**MINUTES OF THE REGULAR MEETING OF THE
PLAN COMMISSION, VILLAGE OF TINLEY PARK,
COOK AND WILL COUNTIES, ILLINOIS**

June 3, 2021

ITEM #1 PUBLIC HEARING – FLOOR & DÉCOR REDEVELOPMENT, 7061-7063 159TH STREET – ARCHITECTURE/SITE PLAN APPROVAL AND SIGN VARIATION

ITEM #3 PUBLIC HEARING – TINLEY PARK BUSINESS CENTER (SCANNELL) INDUSTRIAL DEVELOPMENT, 19501-19701 HARLEM AVENUE – REZONING, SPECIAL USE FOR A PUD, FINAL PLAT OF SUBDIVISION, SITE PLAN/ARCHITECTURAL APPROVAL

Proposed Site Plan

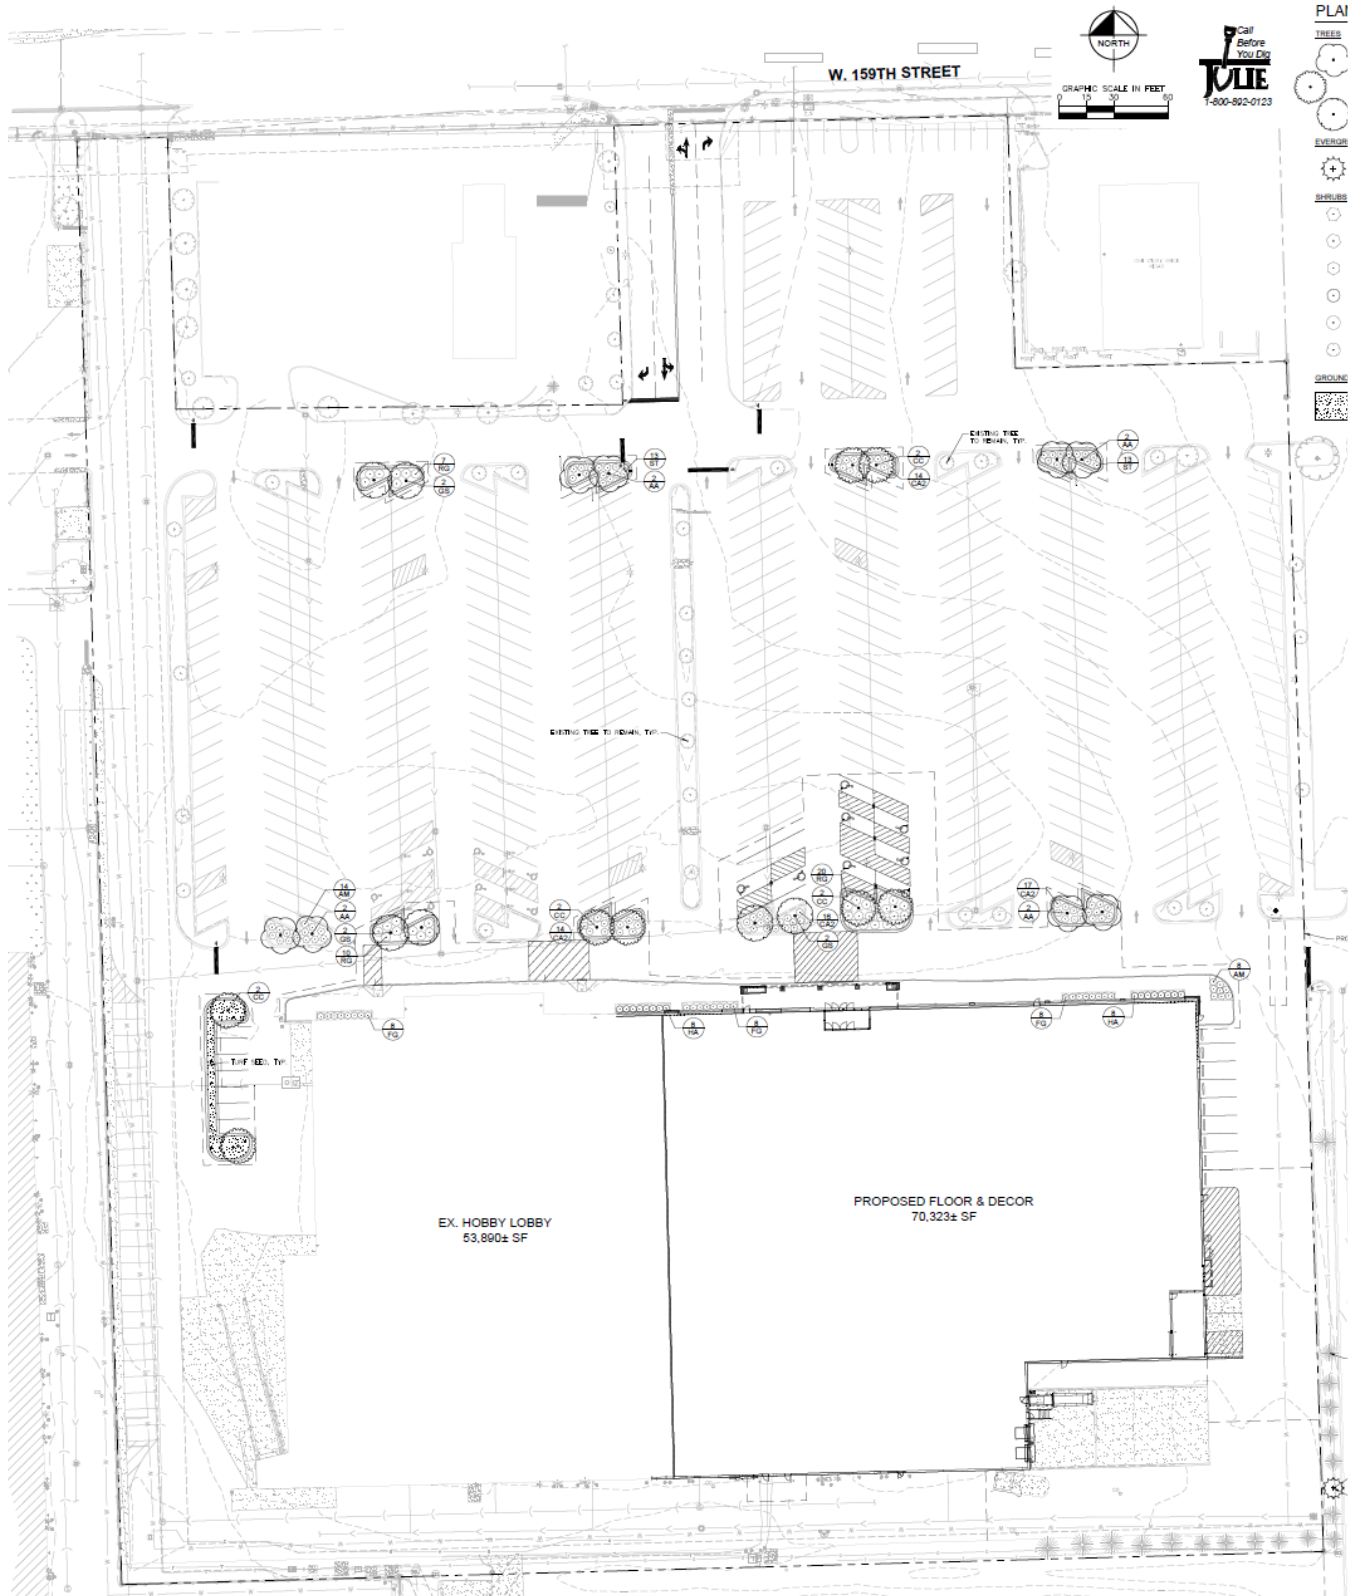
Open Item #4: Review overall site plan and site circulation based on Site Plan Standards.

The plans are still under review from the Village Engineer and are subject to their final review and approval in regards to traffic control and grading. Staff has recommended a standard condition that the approval be subject to Final Engineering Plan review and approval.

Open Item #5: Staff is recommending the site plan approval be conditioned upon final engineering review and approval.

The overall site plan was seen as a big improvement to its overall appearance and in regards to traffic control and landscaping. A condition has been added requiring final engineering review and approval for the proposed changes.

Above: Plan of Proposed Site Changes.

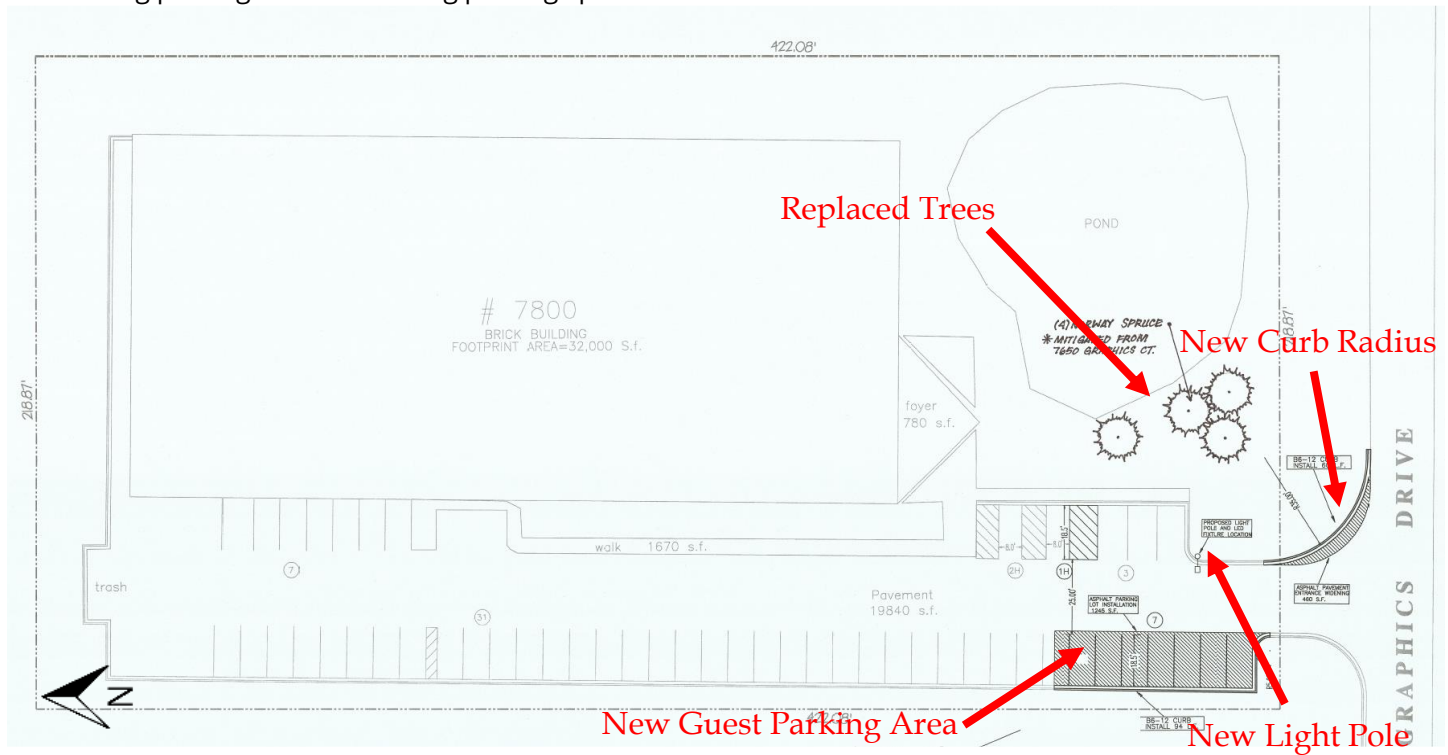
The primary purpose behind the plan is to increase the available parking on the site as much as possible. The additional parking has been needed due to growth in their business and increased production. The result is the addition of 8 new parking spaces at the southwest corner of the site where there is existing green space adjacent to the existing parking lot. One existing parking space will be converted to an access aisle for a net increase of 7 stalls.

The new parking stalls are located in the front yard which is not permitted, except for single-family residences (who can park on driveways in the front yard). Parking in the front yard requires an exception to the code. The Petitioner has proposed this location for additional parking because it is the best location to add visitor parking near to the main entrance, separate from employee parking. The subject site already has existing front yard parking, and the proposed additional parking will just be extending the existing parking row on the west side of the site. Additionally, there are other sites in the area, including those that have front yard parking (see image below) that are existing or approved. The proposed front yard parking Exception will not negatively change the character of the overall PUD area or the street frontage.

Open Item #1: Review the overall site plan layout and Exception for front yard parking, where it is prohibited.

Since engineering and stormwater management aspects have not been fully submitted or reviewed by the Village Engineer, staff recommends the typical condition to clarify that the approvals are subject to final engineering review which will be submitted with the building permit.

Open Item #2: Staff is recommending the site plan approval be conditioned upon final engineering review and approval.

Above: Extent of Phase 1 site work shown in dark grey. Detention, utilities, and right-of-way improvements, and the landscape berm in front of building 1 and 2 will also be part of Phase 1.

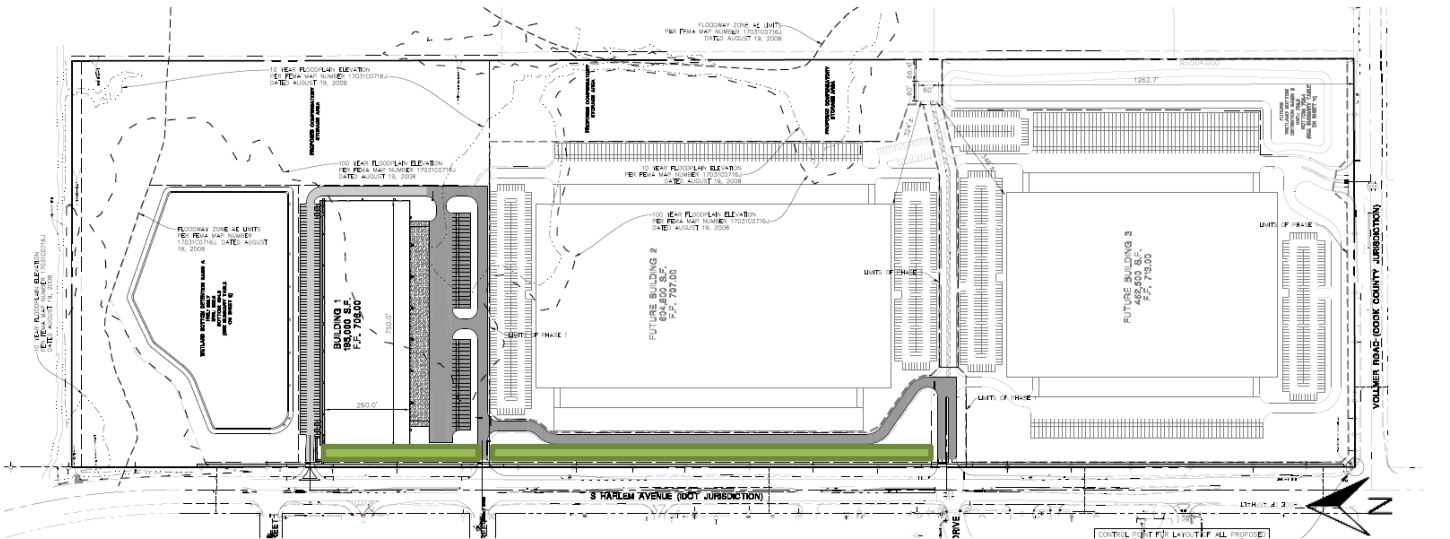
Open Item #2: Discuss and review the overall conceptual site plan and phasing.

Harlem Avenue Berm

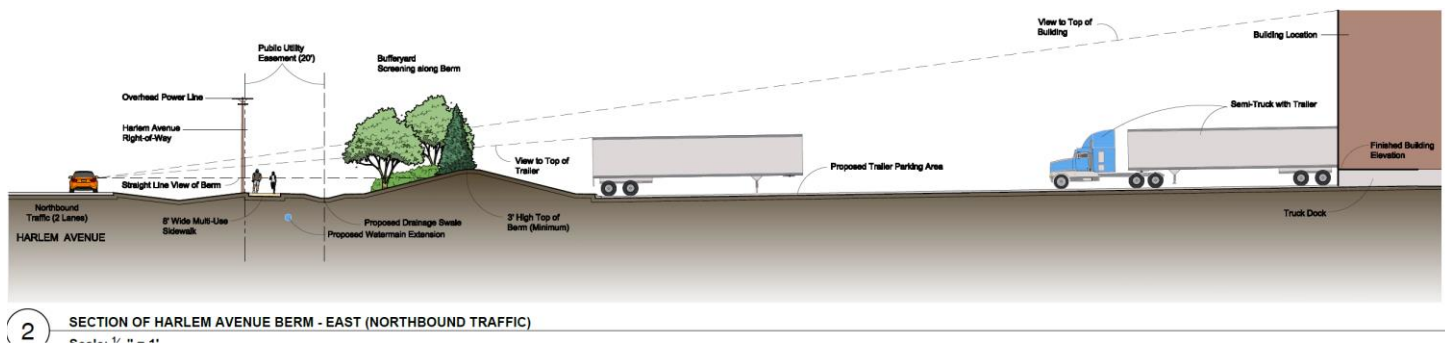
One concern based on the design was the location of truck docks and storage adjacent to Harlem Avenue. While the preference is typically for these items to be located in the rear of buildings, the limited building area and need for cross-docks required them to face the roadway on this project. This specifically happens with buildings 2 and 3. Rotating the building's docks on those to face north and south (similar to building 1) severely limits the overall size of the buildings and the number of docks due to the buildable area of the site. Those alternatives were explored but are not marketable for the developer to potential tenants.

To mitigate the potential views of the docks and trailers along Harlem avenue, a landscape berm has been proposed. The berm includes a 3 to 4-foot-high grade increase along with landscaping planted on it. The image above shows a cross-section of how views from Harlem avenue looking towards buildings 2 and 3 with the 3 to 4-foot-high berm.

The landscape berms are covered by a "Landscape Easement" on the Final Plat of Subdivision requiring the be maintained per the approved plans. The easement provides the Village access to maintain the berm in the future if need be and can recoup any costs by mechanisms established in the Annexation Agreement. This insures the berm will be properly maintained beyond the original developer and owner of the land.

Above: Existing watermain (blue), required extension for the development (purple), and additional extension beyond the development to create water system loop (red).

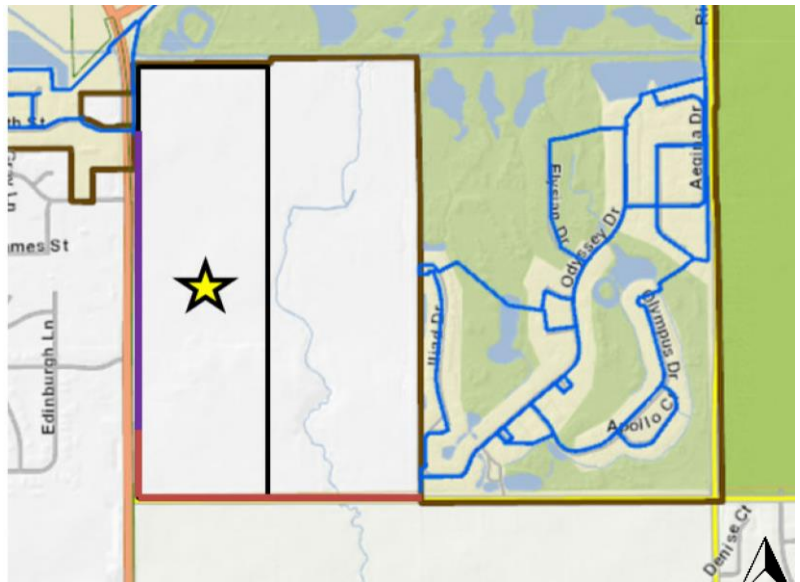
To complete the watermain loop, the developer will need to extend the watermain much further than their development requires down Vollmer Road (shown as the red line on the image above). The developer has agreed to complete this work with their project to create the benefit to their development and the larger community. Any cost reimbursement for watermain beyond their development's requirements will be covered within the Annexation Agreement. The watermain work will be completed with Phase 1 of the project. In addition to water, other utilities such as sanitary and storm sewer will be run to the sites but phased with the development since they are not as crucial to public safety. The location of the utilities will be located on the private site within a utility easement based on the preference of the Public Works Department to not have the utilities in IDOT right-of-way.

Open Item #4: Discuss proposed watermain extension and utility improvements.

Building 1 Final

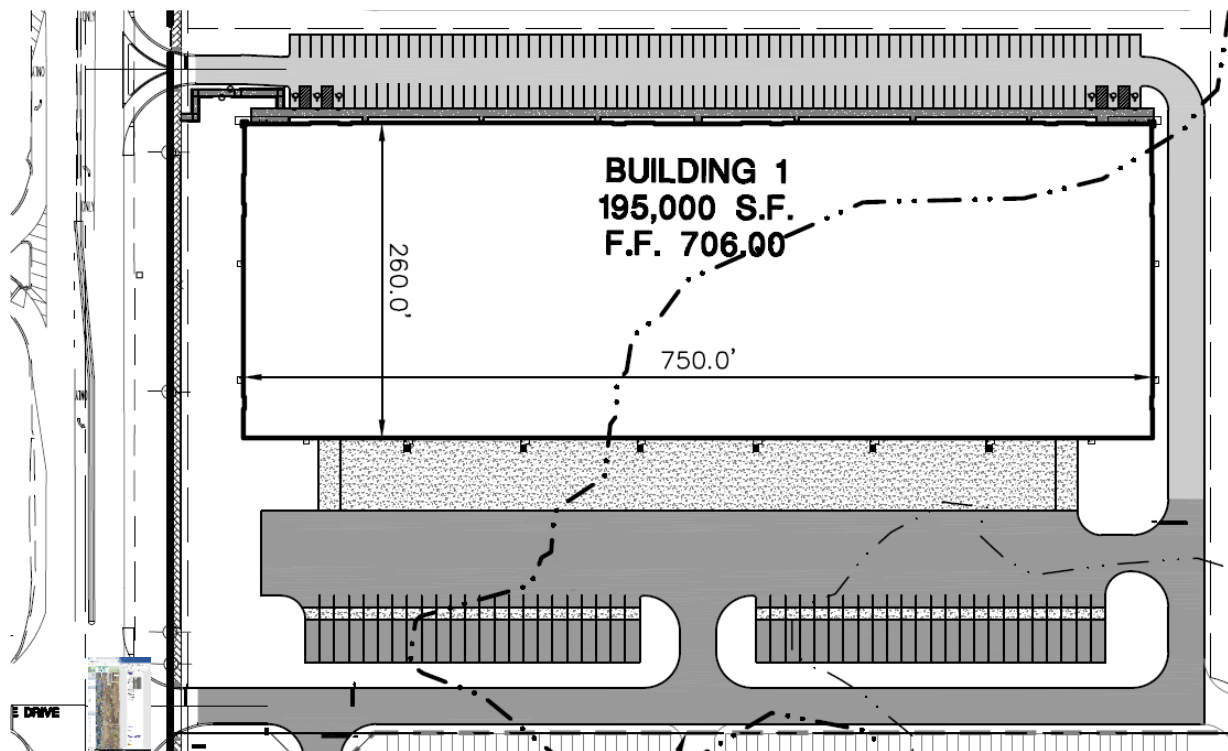
As part of Phase 1, final approval is being given to the building 1 site. The site includes an approximately 195,000 sq. ft. building, 125 parking spaces on the north side of the building, 24 docks and 50 trailer storage locations on the south side of the building. The site will tie into the internal roadway system and will have access to three access points including the signalized intersection at Benton Drive that will be constructed with Phase 1. The building is setback 63' 9" from the Harlem avenue right-of-way line. In that setback will include the 2 to 2.5-foot-high landscape berm to help block views of the docks and trailer storage in front of building 1. The berm will then go up to 3 to 4 feet in height as it moves south where building 2 is proposed on the concept plan. All garbage will be kept internal to the building and placed outside on pickup days only.

Open Item #6: Discuss the final site plan approval for Building 1.

Building 1 – Final Approval

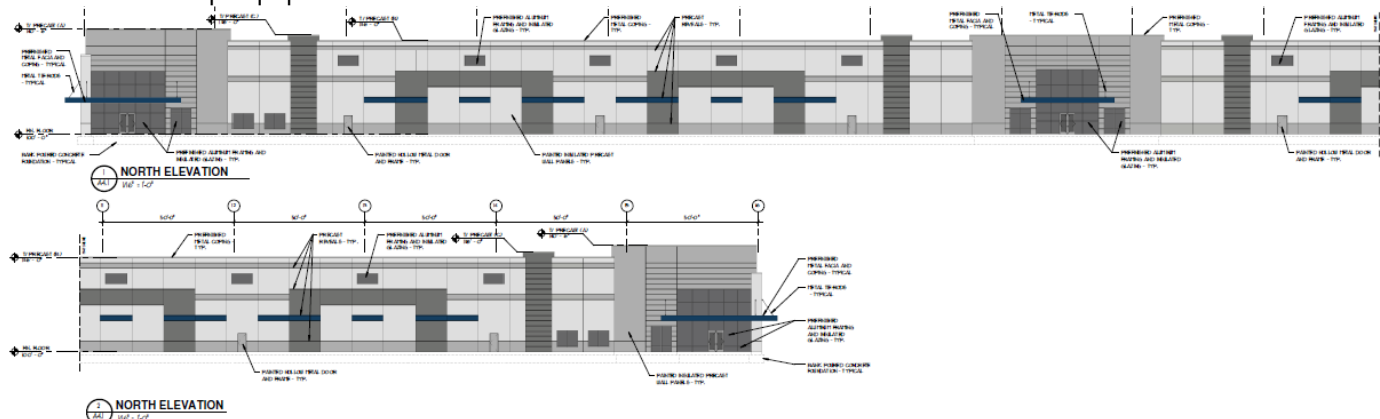
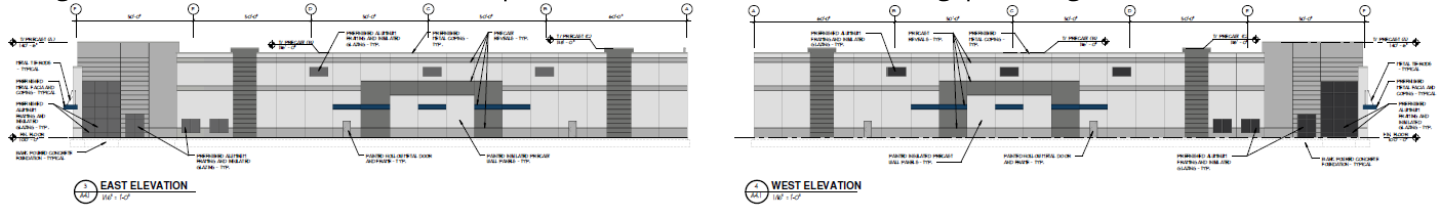
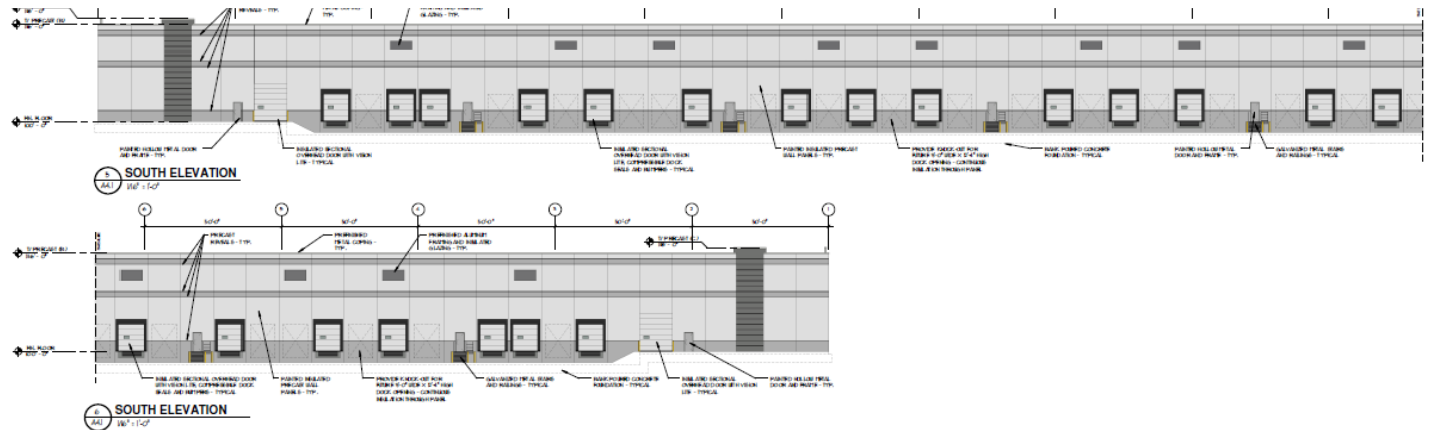
The building will be largely constructed of precast concrete panels. There are three glass architectural elements to anchor the building's two corners and the center for the north/front façade that will be most visible to Harlem Avenue. While the total number of tenants and internal layout will be determined based on the tenants chosen, this provides a natural space for up to three main entrances for employees. Canopies have also been placed over the entrance points to draw attention to them as customer or employee entrances. Overall there is articulation in the buildings appearance and roof line that makes it look attractive and not "boxy". The rooftop parapet has been designed to screen all rooftop equipment from view of the street.

The rear/south side of the of the building is where the dock location has been proposed. However, the common architectural design elements have been carried through to this side. Due to the unknown needs of the future tenants, some of the docks have been proposed to be installed while other locations will have “knock-out” areas where docks doors can be added or enlarged if needed by the future tenants.

Open Item #11: Review and discuss the proposed architecture of building 1 and need for any overall development standards.
